Clonburris SDZ, Reg ref: SDZ22A0010
Dublin 22

Ronan Mac Diarmada & Associates
Landscape Architects & Consultants

**CLARIFICATION OF ADDITIONAL
INFORMATION RESPONSE**

March 2023

Plaza 1 : Urban Plaza

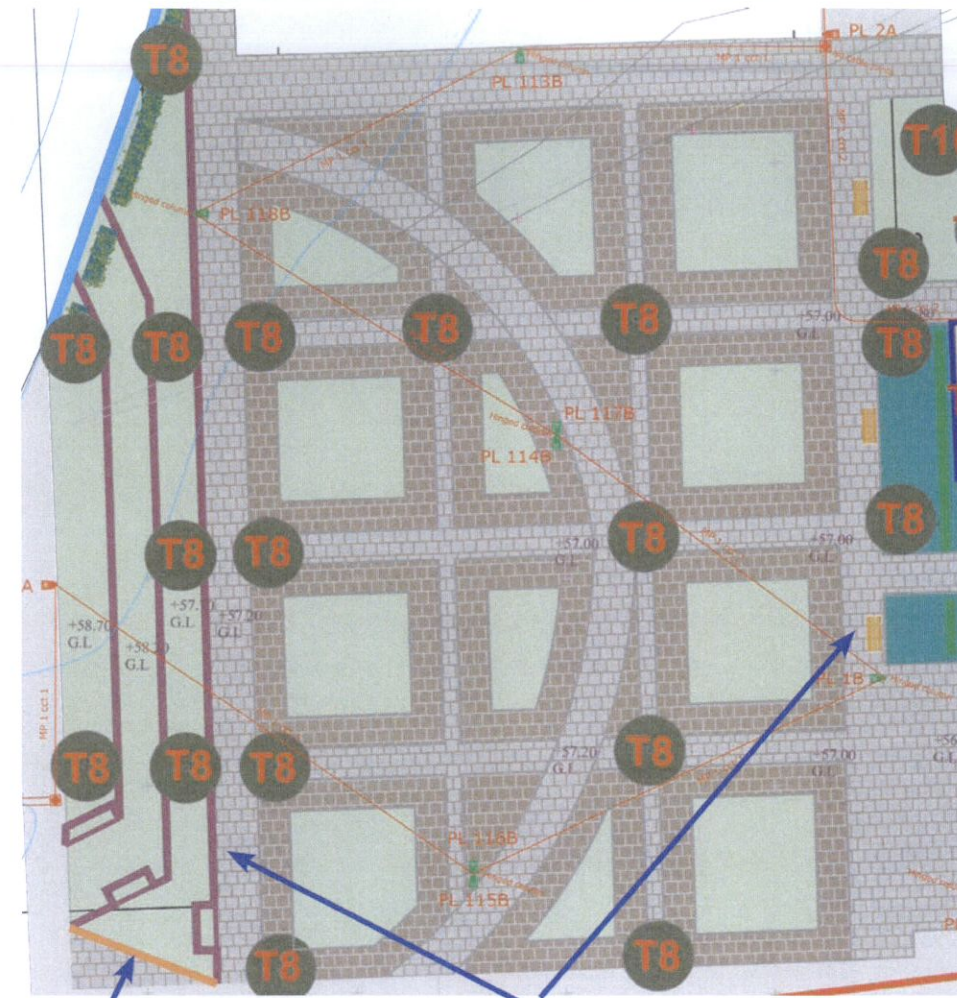
(a) Further information on the opportunities for plaza enclosure on the western and eastern edge of the plaza is required as there are technical concerns with the proposed solutions. Further green infrastructure and SUDS should be incorporated in the public urban plaza.

(a) Please refer to diagram shown on page.

1) A feature signage wall will act as the main focal point to the site and to the urban plaza, where a creche & commercial/retail unit will be located.

2) Seating will be located on the perimeter of the plaza in the form of benches to the east & low terrace wall to the west of the plaza.

3) Columnar tree planting will enclose the central space, creating sub spaces where a range of activities can occur such as day markets or areas of play.

4) Suggested location of art pieces with possible seating opportunities to be agreed with Arts Officer & Artist.

Plaza 1 : Urban Plaza SuDs

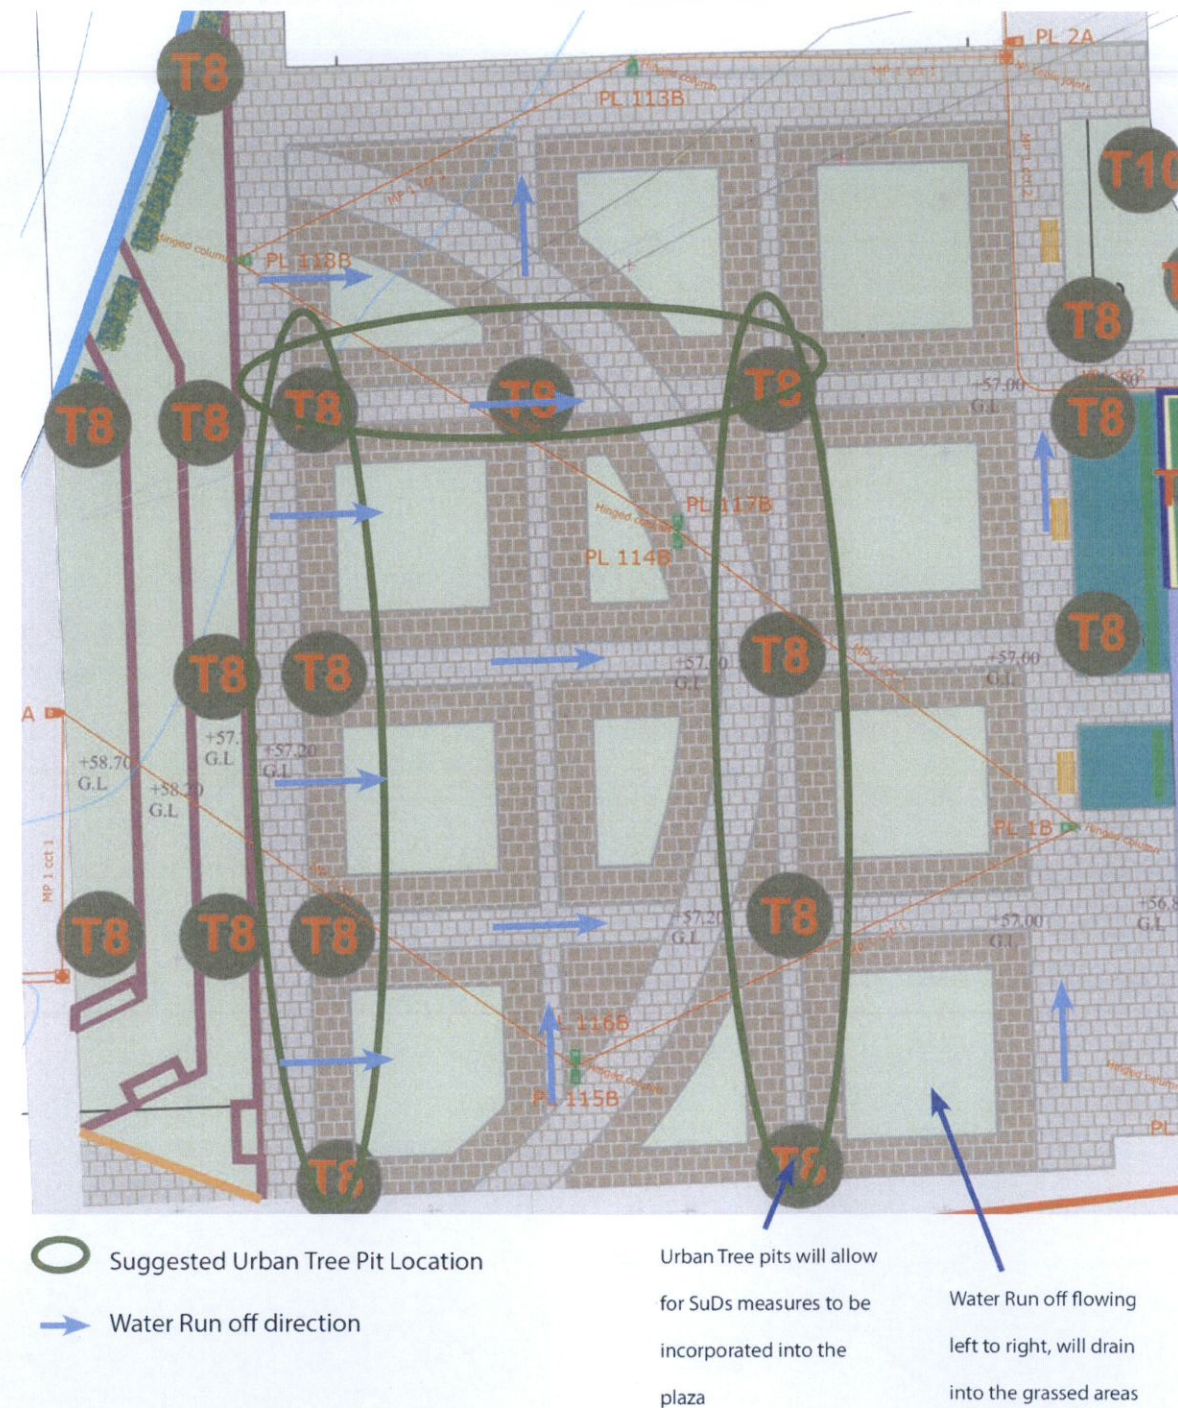
(a) Further information on the opportunities for plaza enclosure on the western and eastern edge of the plaza is required as there are technical concerns with the proposed solutions. Further green infrastructure and SUDS should be incorporated in the public urban plaza.

(a) Please refer to diagram shown on page. The urban plaza to the west of the site, allows for water run off into the green spaces to allow for drainage.

Urban tree pits will be implemented for the trees located within the plaza. These shall form part of the SuDs implementation on site.

We have included for further green infrastructure in the plaza by introducing green areas into the surface. However, we note the SDZ document requires "continuous surface & continuous gradient".

The water run off will flow into the green areas and the urban tree pits. Acco-channel drains will be located to each entrance to a building.

Plaza 2 : Eastern Open Space SuDs

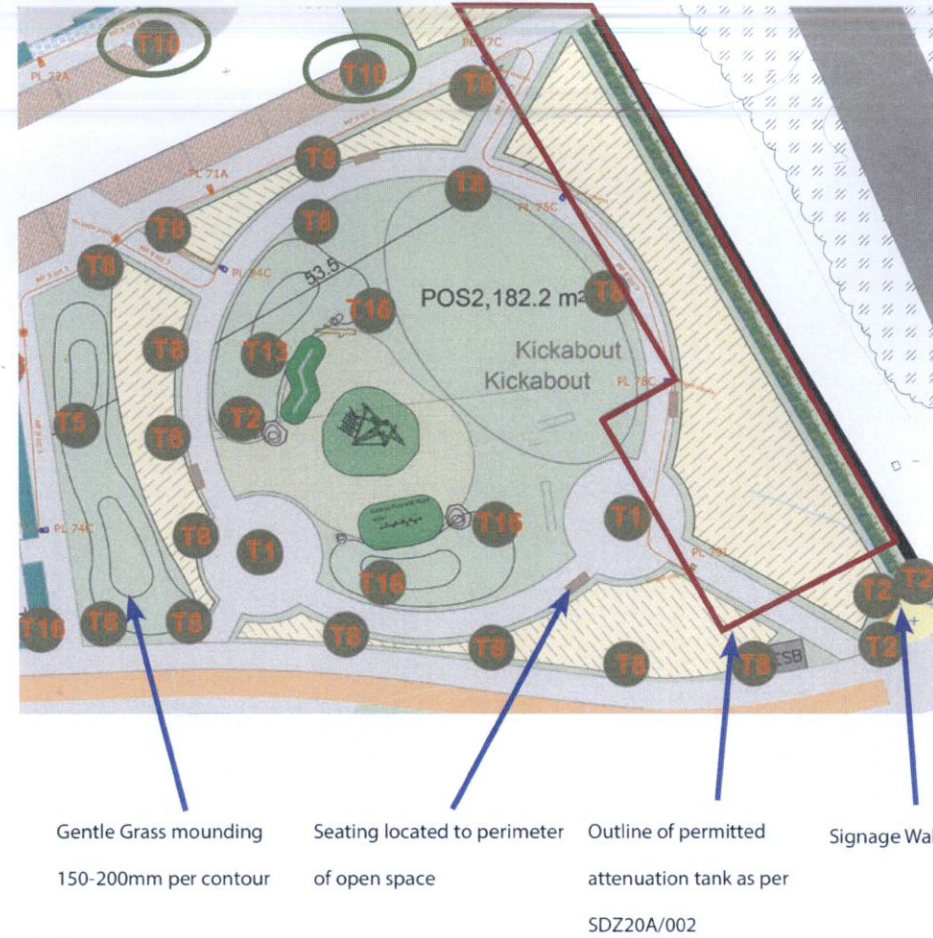
(a) Further information on the opportunities for plaza enclosure on the western and eastern edge of the plaza is required as there are technical concerns with the proposed solutions. Further green infrastructure and SUDS should be incorporated in the public urban plaza.

(a) Please refer to diagrams shown on page. The eastern open space, will accommodate a new proposed play area, kickabout area and incorporate the permitted attenuation tank, located in the open space. Water will run off into the grassed areas.

Similarly to the Western plaza, a signage wall will be located in this space and will act as a focal point.

Seating will be located on the perimeter on circular path in the form of benches, and will allow passive surveillance to the play area.

A mix of natural play items, gentle grass mounding and feature tree planting will create an interesting space for children and adults to congregate in.

Communal Open Space at Block A

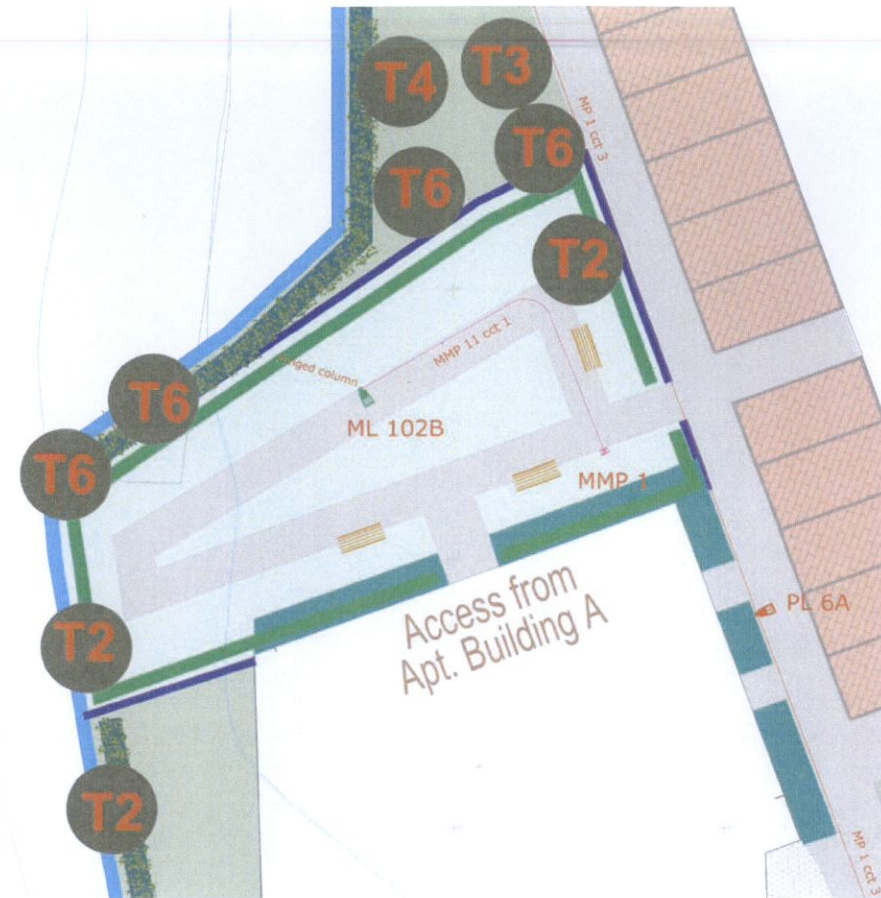
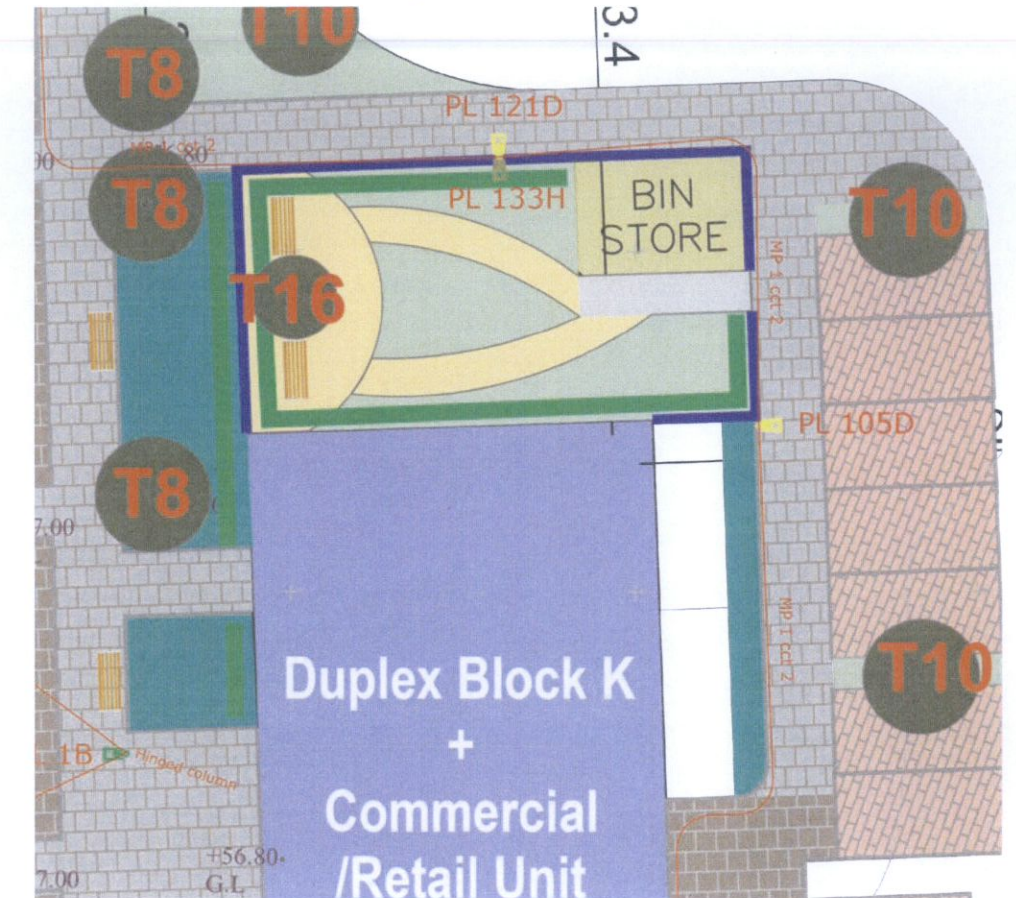
In relation to AI Item No.3 insufficient detail and consideration have been given to the layout and design of the communal open spaces. The communal open space for Block A in particular is not considered to have an overly usable shape and is closed in to the north by a water tank, bin store and bicycle store: access to these is not clear. This open space is indicated as narrow strips of open space along the eastern and northern sides of Block A, directly adjoining and overlooked by the creche unit.

The applicant should also be requested to address the accessibility of the communal open spaces for residents. There is a stairwell in Block A with direct access to the communal open space located to the north, although hedgerow planting is currently proposed across this access. Accessibility for mobility impaired should also be provided directly from the building to the communal open space (stairwell does not include lift). It does not appear that the communal open space for Block B is directly accessible from the building itself.

There does not appear to be any provision of communal open space for the units in proposed Block K (apartments proposed)

The communal open space at Block A has been revised to address the accessibility issue of the space. The layout has been revised so that it omits the bike parking and bin store from the open space. This will allow for a much larger usable open space. There is now direct access from Block A to the communal open space. Hedge planting around the perimeter of the site will provide some privacy to the space.

Block B has been omitted in this proposed iteration of the development.

Block K will also provide a communal open space accessible from the path adjacent from the parking. Hedge planting and a railing will provide privacy to the space.

Section 1. Through Local Intimate Street (north of Site)

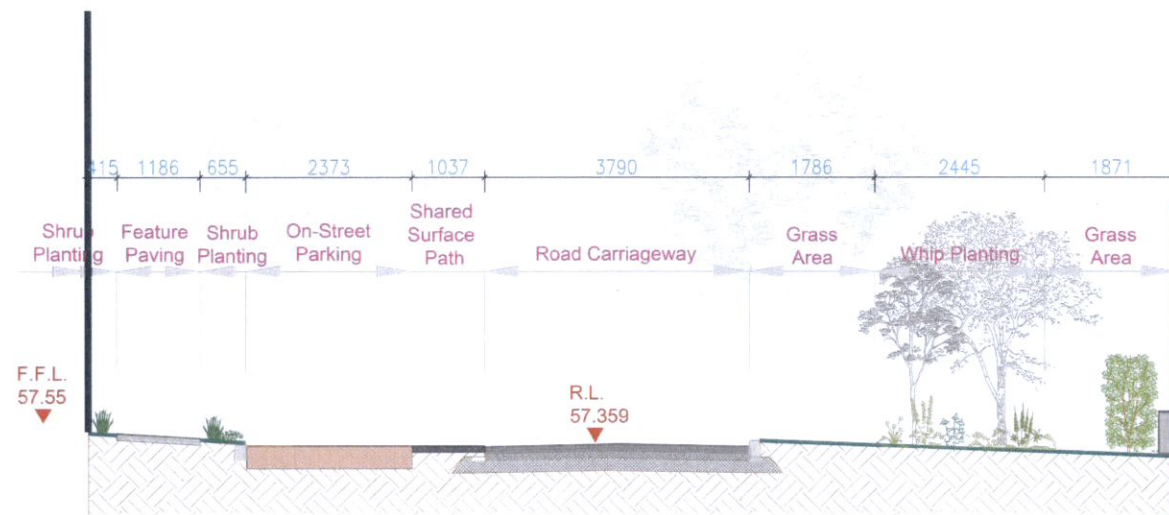
The Planning Authority and Roads Department still have significant concerns in relation to the designation and design of the street network and types. The proposed development includes Intimate Local Streets/ Homezones where they are not included in the Planning Scheme. The only Intimate Local Street/Homezone within the subject site, as indicated in Figure 2.2.7 in the Planning Scheme, is located in the centre north of sub-sector CSE-S1. Any other Intimate Local Streets/Homezones outside of this should be redesigned as Local Streets, as designated under the Planning Scheme. Given the location of the east-west local street along the north of CSE-S1 this should be designed with a fully shared surface for the integrated movement of vehicles, pedestrians and cyclists.

The designated Intimate Local Street/Homezone in the east of the site should be significantly redesigned to comply with the Planning Scheme. Perpendicular car parking on both sides of the Intimate Local Street/ Homezone, whether on-curtilage or off-curtilage, is not in compliance with the Planning Scheme. The Intimate Local Street/Homezone should extend the full extent of this street and the on-street perpendicular car parking at the northern end of this street should be omitted. The footpath should be 2.5-4.0m along this street.

The applicant is requested to submit revised plans indicating revised details. Dimensioned cross sections of all street types with comparison to the Planning Scheme should also be provided.

Please refer to the section provided showing the dimensions and typology set out in relation to the guidelines in the Clonburris Planning Scheme.

In the intimate local streets, the combined road and path shall be a shared surface and shall provide for greater access for pedestrians with Street Planting where possible.

Existing & New Native Hedge Plan

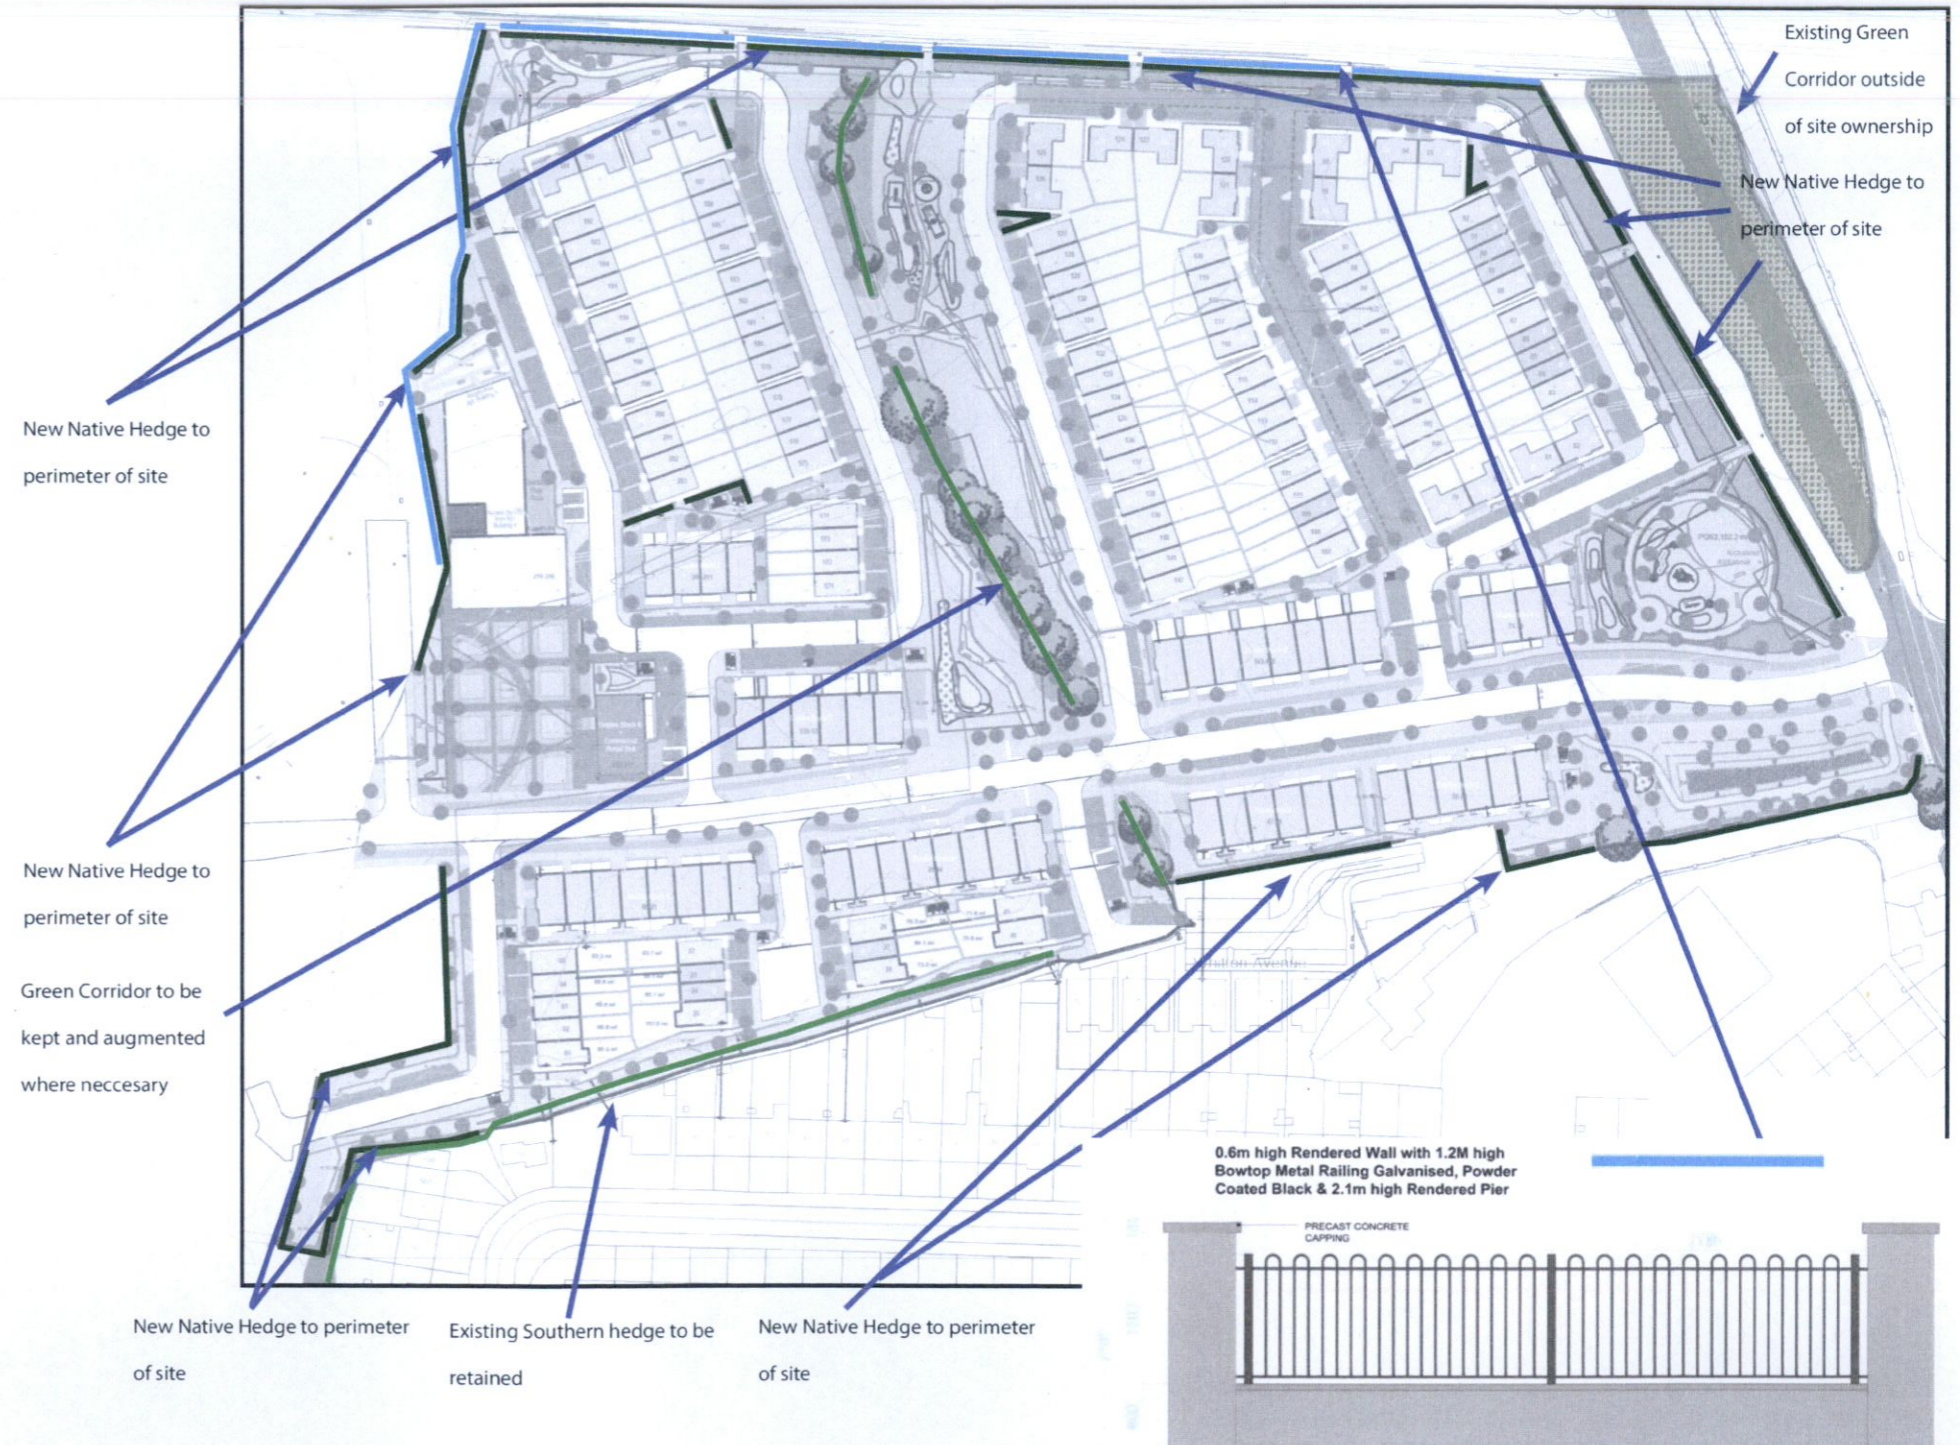
(a) The Planning Authority would have concerns with the retention of the current boundary treatment along the northern and eastern boundaries as part of the proposed development. These spaces are considered vital to the successful deliver of this section of the SDZ. It is therefore considered that the application must engage with the adjoining landowners to the provide the Planning Authority certainty as to the delivery of these areas. As a minimum the replacement with a more visually acceptable boundary treatment should be facilitated through this application.

(b) The Planning Authority and Public Realm Section would have concerns with the loss of habitat onsite and green infrastructure proposed. It is not considered that the proposed development fully complies with the agreed Parks and Landscape Strategy for the SDZ.

(a) The Eastern boundary consists of a 1.2m railing and a palisade fence to the northern boundary. We propose the eastern boundary to be retained as the railing is of good quality. A native hedge will be used to supplement the railing.

For the northern boundary, there is currently no existing hedgerow to the northern boundary. It is proposed to the north with the adjoining landowner, Irish Rail to provide a butt wall & railing supplemented with a native hedge. There will be breaks in the wall to allow for circulation to the railway link. This wall will be 0.6m high with 1.2m railing.

(b) The majority of the green infrastructure on site has been retained. The arborist dwg and reports have shown a singular hedge and parts of the central & southern hedge to be removed to accommodate the proposal with some trees to be removed due to poor quality. The hedge to the southern boundary is in poor condition, we propose to augment with Native hedgerow.
